# Addendum

**PROJECT:** Greenville National Bank Renovation

**PROJECT ADDRESS:** 446 S Broadway Street  
Greenville, Ohio 45331

## **ADDENDUM NO. 3**

SHEET NO.  
A0.5

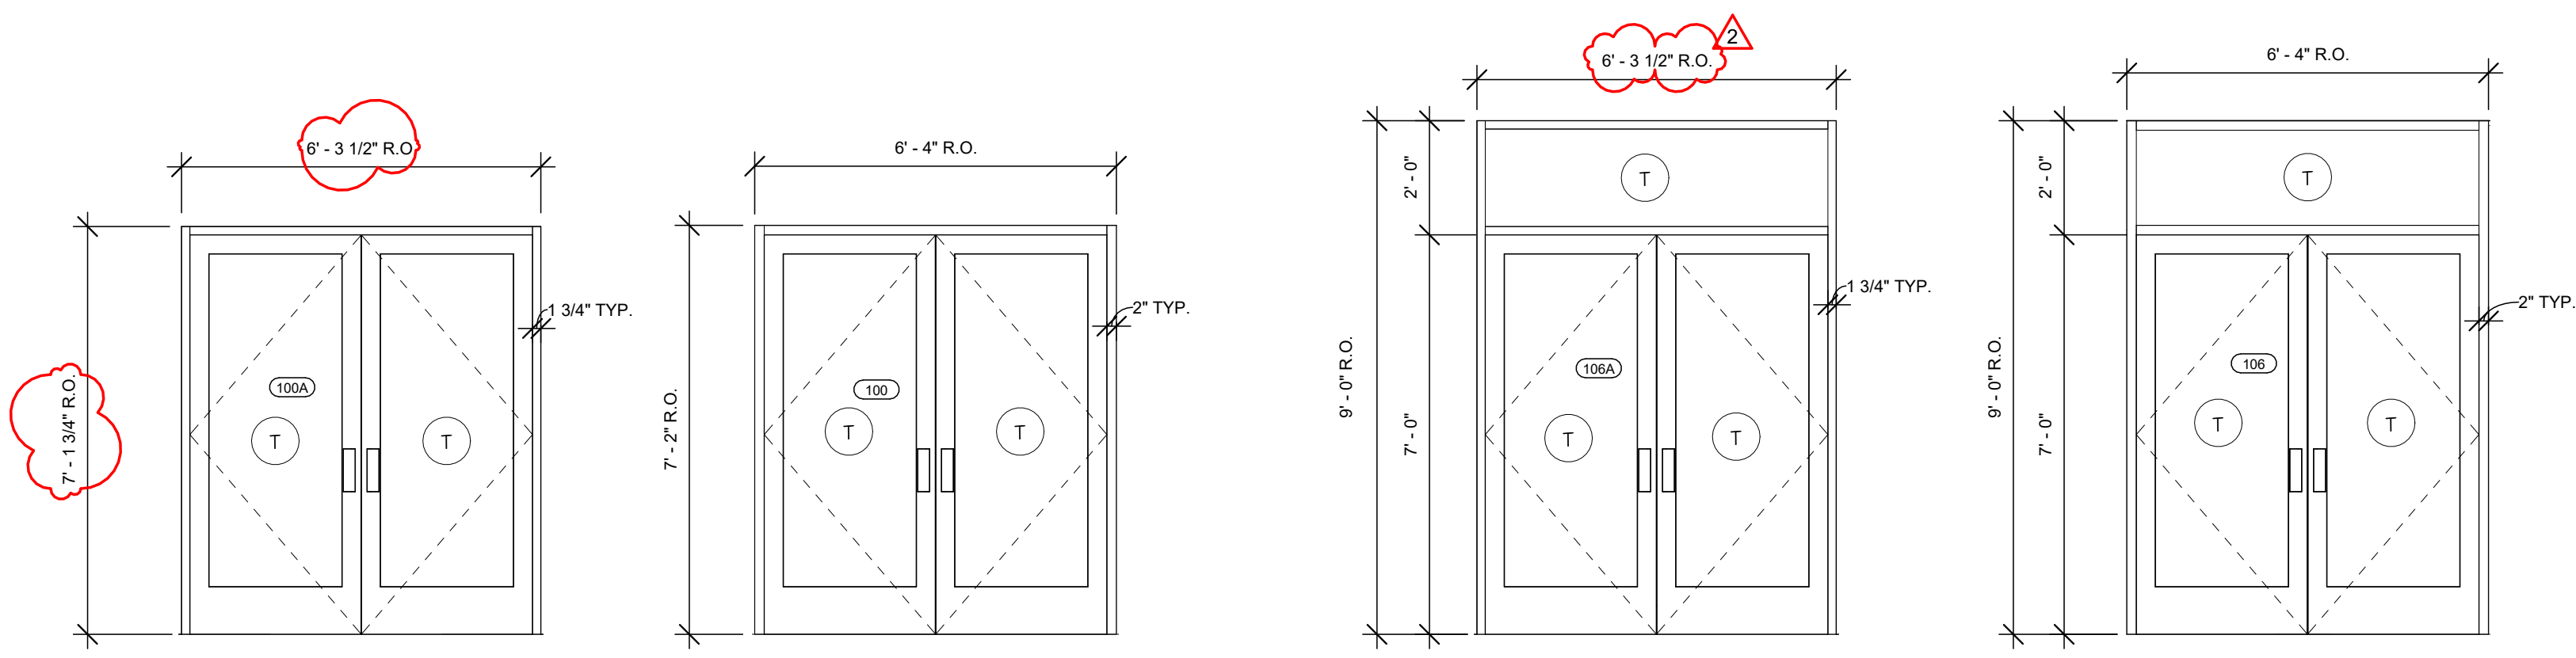
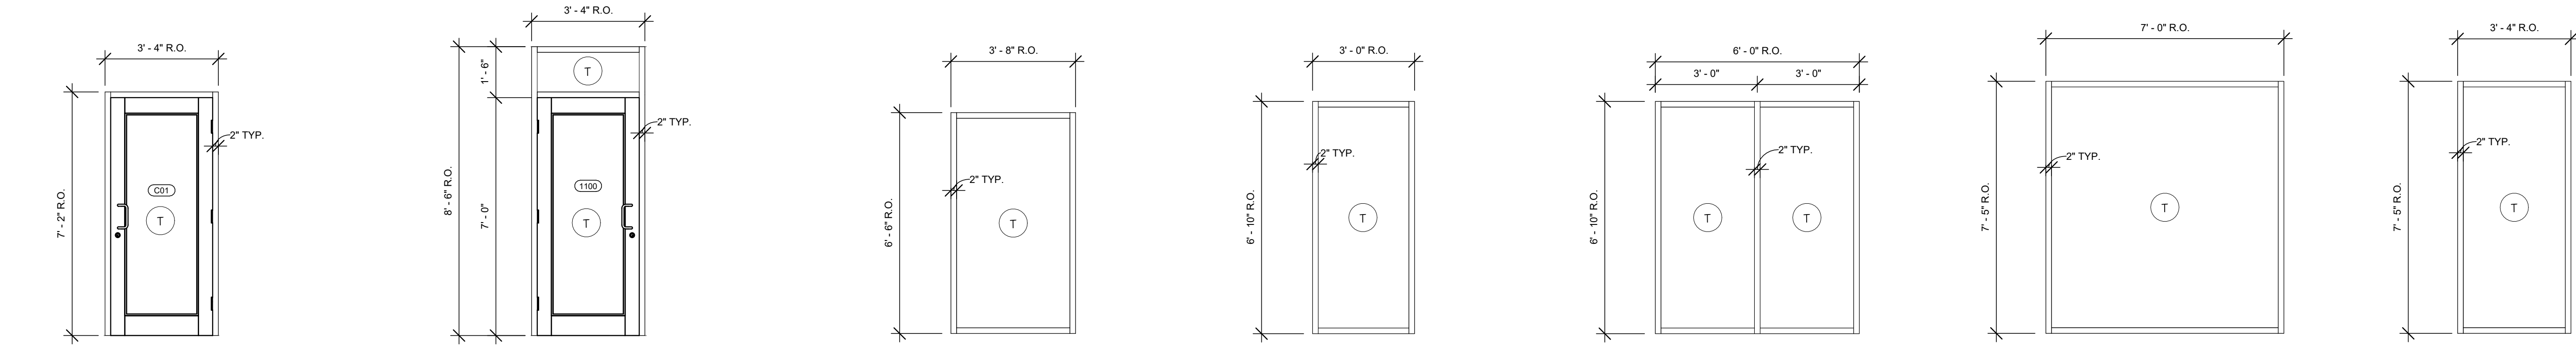
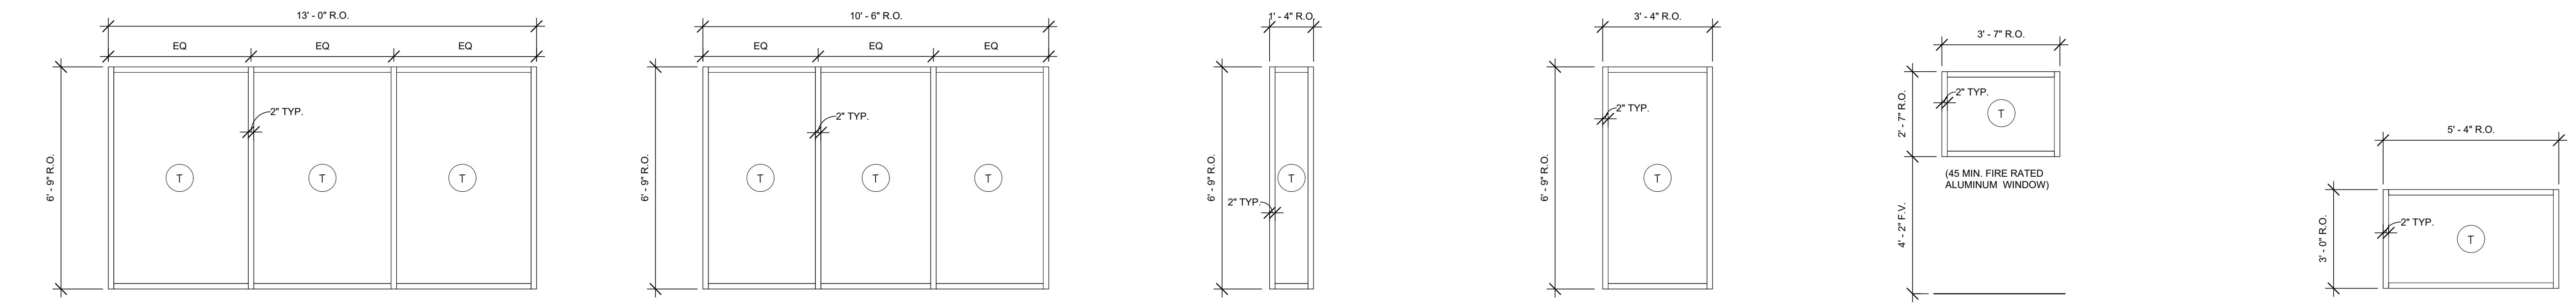
- Q16: What is the thickness of the exterior aluminum doors? Specs call for 2-1/4". Door schedule calls for 1-3/4".  
A16: Exterior aluminum storefront doors are to be 2-1/4" in thickness. Door Schedule has been revised to reflect this.

- ITEM A1 SHEET A0.3 – DOOR SCHEDULES  
1. Revised door thickness for 1100, C01, 106, and 100.  
2. Revised door frame width to 6’ - 0” for doors 100A and 106A.  
3. Revised fire rating for door B03.
- ITEM A2 SHEET A0.5 – STOREFRONT SCHEDULE  
1. Revised dimensions for SF-17 and SF-15.

**F2** BASEMENT REFERENCE PLAN  
1/8" = 1'-0"

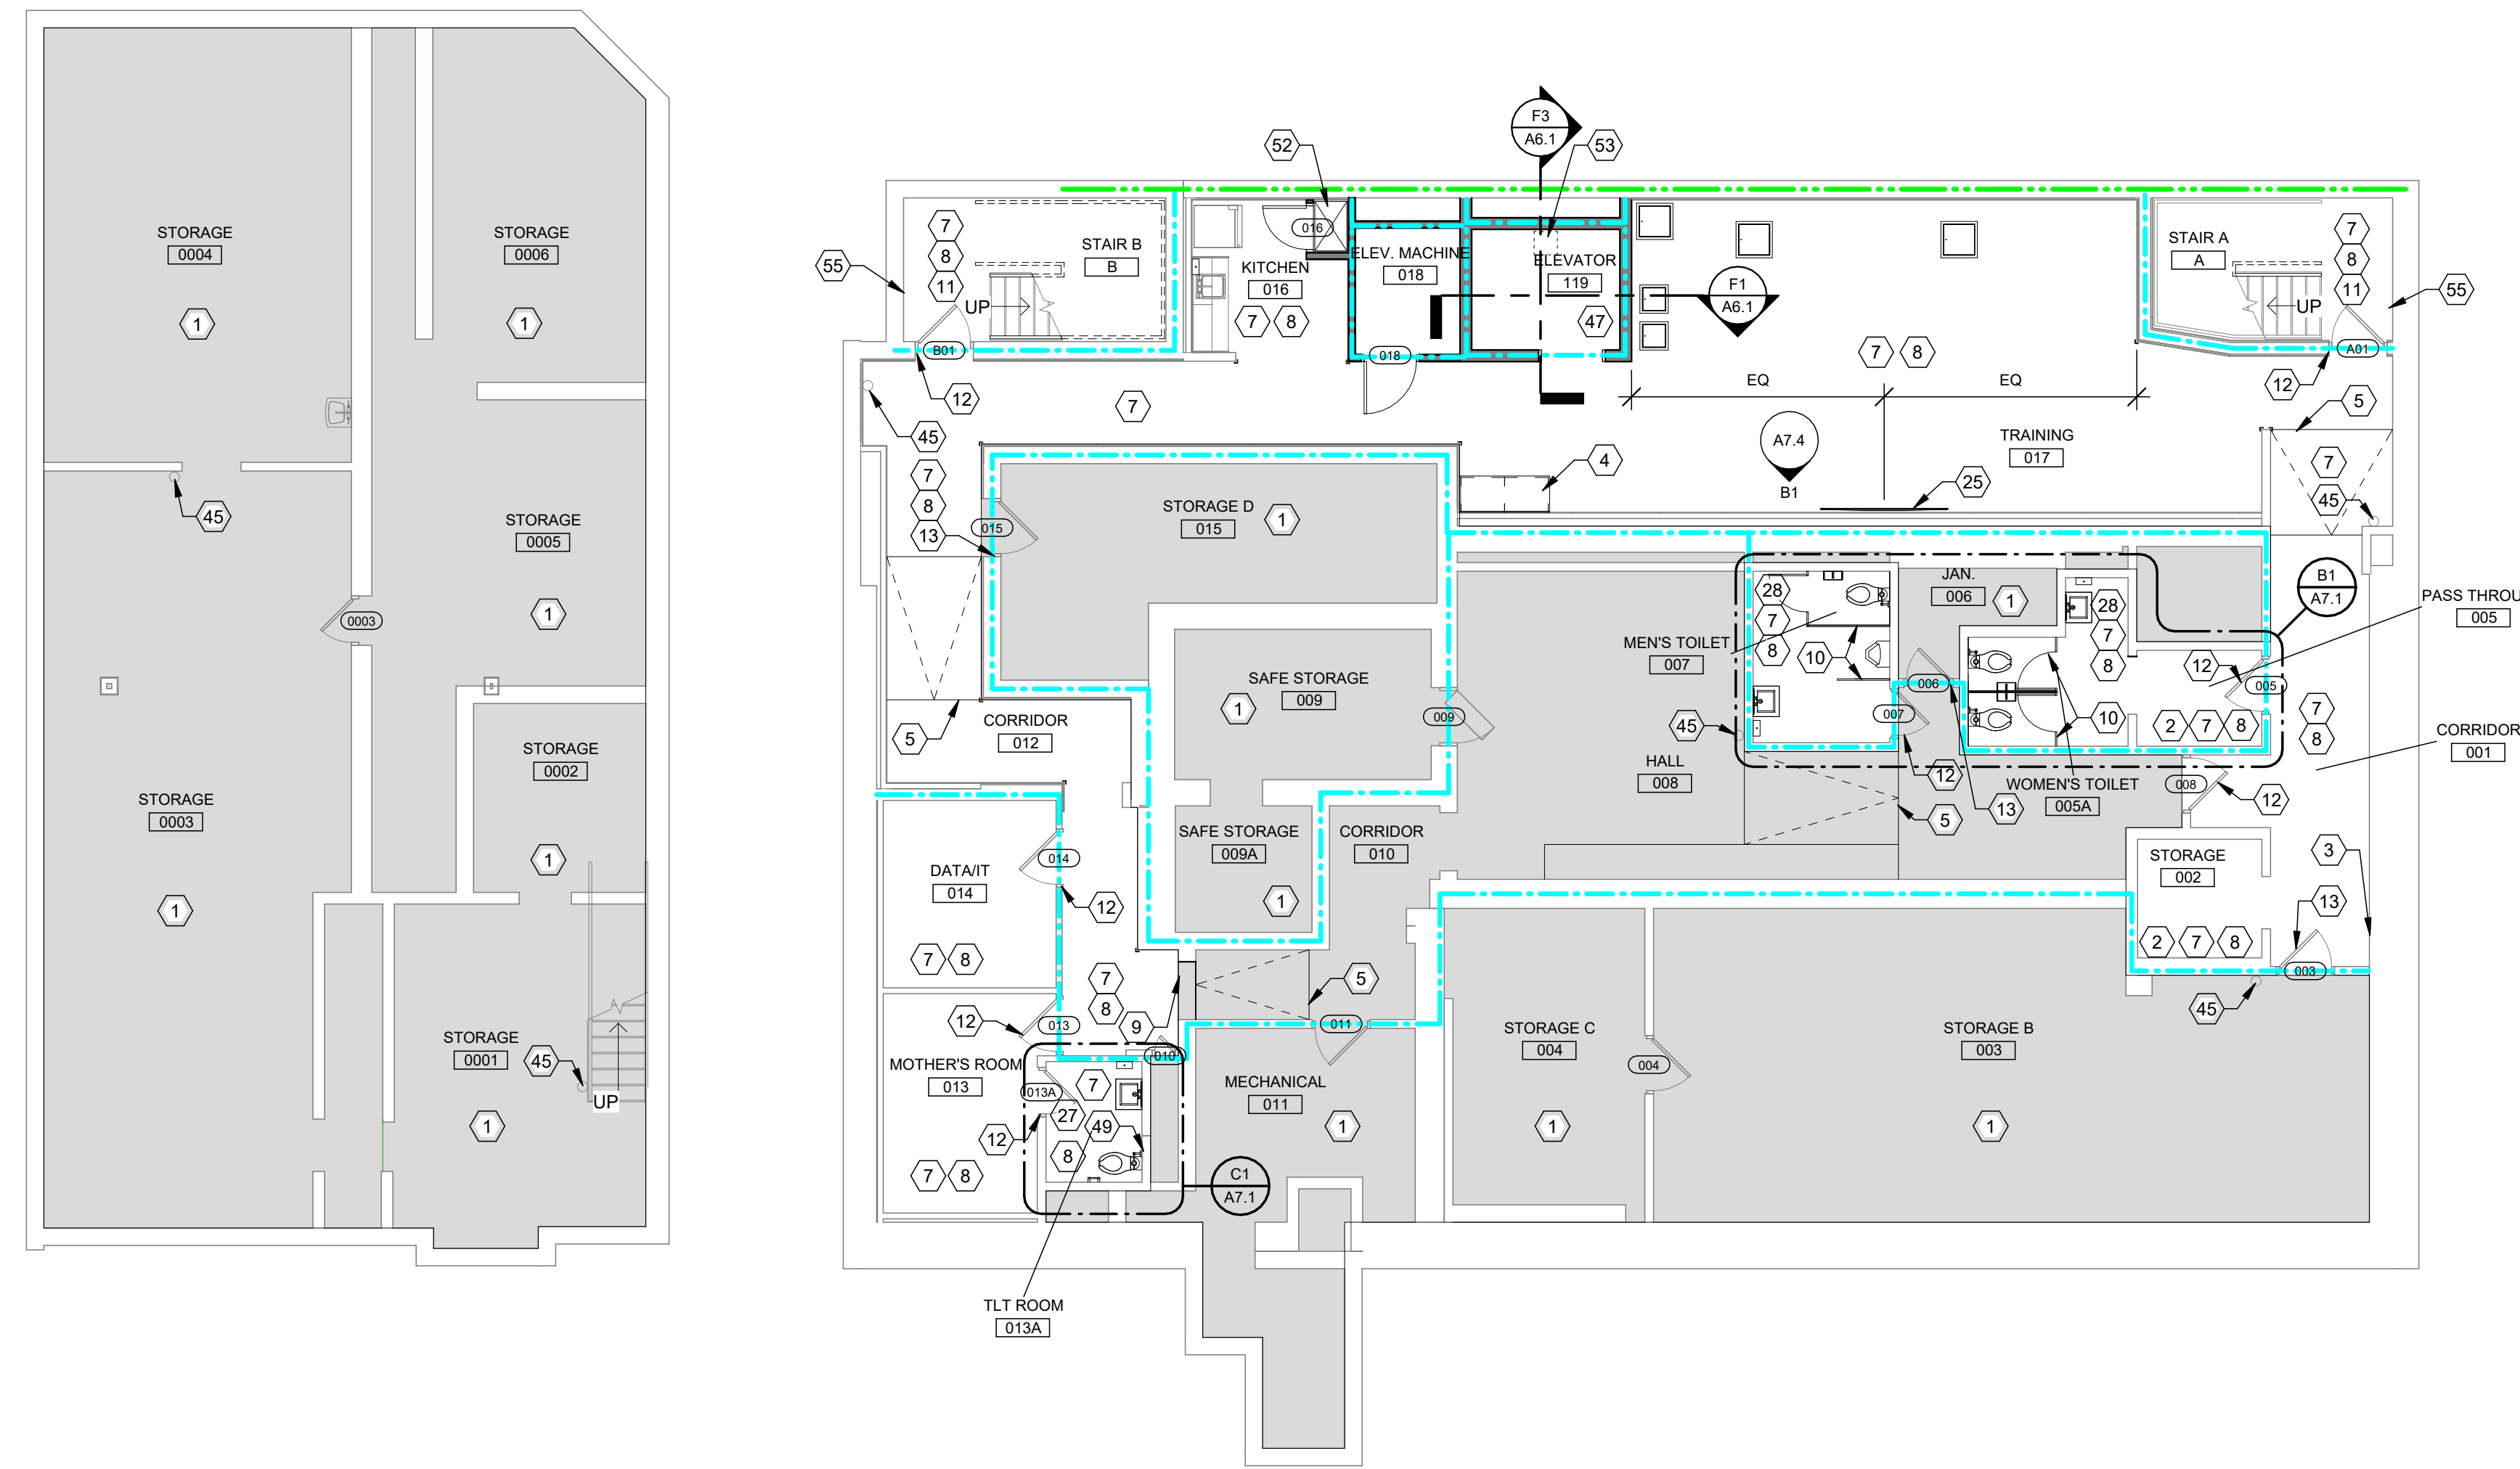
- Q11: With the extent of the waterproofing/remedies at the Main Building East basement walls unknown, can the architect establish an allowance for the General Contractors to carry?  
A11: Construction Note 3 on A1.2 has been revised. GC is responsible for replacing approximately 50 SF of gypsum board and evaluating any further repairs necessary. If more repairs are necessary, the cost will be covered by the Owner's contingency.

ITEM A3 SHEET A1.2 – BASEMENT REFERENCE PLAN  
1. Revised Construction Note 3.

- 25 PROVIDE BLOCKING IN WALL FOR OWNER SUPPLIED TV. REFER TO EQUIPMENT LEGEND ON DIMENSION PLAN SHEET.
- 26 INFILL WALL TO BE FLUSH WITH ADJACENT EXISTING CONDITIONS. PATCH WALL AND PREP FOR NEW FINISHES. NOTIFY ARCHITECT IF WALL TYPE NEEDS REVISED TO MATCH EXISTING CONDITIONS.
